**THE REGIONAL MUNICIPALITY OF YORK  
ADDENDUM # 7  
T-16-11**

**FOR: Construction of the New Paramedic Response Station# 19**  
**LOCATION: 415 Harry Walker Parkway South, in the Town of Newmarket, Ontario**  
**CLOSING: November 18, 2016 at 1:00 P.M. (Local time)**

**YORK EMS STATION #19  
415 Harry Walker Parkway, NEWMARKET  
Regal Project No 2015-124**

This addendum forms part of the Contract Documents and amends the original bidding requirements, drawings and specifications, as noted below.

**E5.0-A-1**

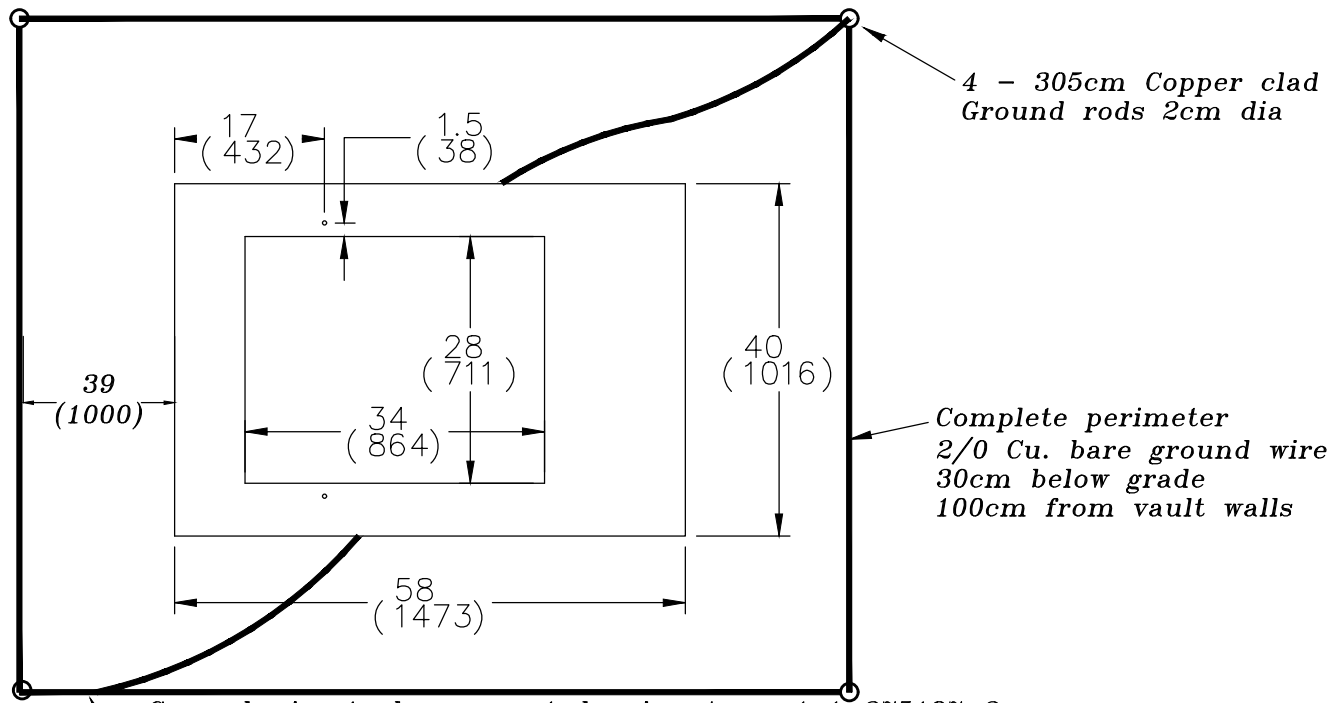
- A** **Metal flashing series to remain as specified.**
- Q10** Addendum #6 noted in the electrical addendum that sketch E5.0-A-1 showing the location of DLM in the ambulance bay is included in the addendum. This sketch is not attached with the Addendum. Can you please forward same.

E5.0-A-1 Lighting Floor Plan

- A** **Sketch E5.0-A-1 is now attached. Please refer to the attached Mechanical-Electrical Addendum ME-2.**
- Q11** Please refer to *Drawing A1.5 – Railing Elevations and Details*. Please refer to *Section 03 30 53 – Cast-in-Place Concrete*. Please provide further description on the architectural finish noted on the drawings. The specification section mentions to match color and texture in section 03 30 53 – 3.12.5.6. and sandblasting in Section 03 30 53 – 3.12.7.

Refer to detail from Newmarket Hydro.
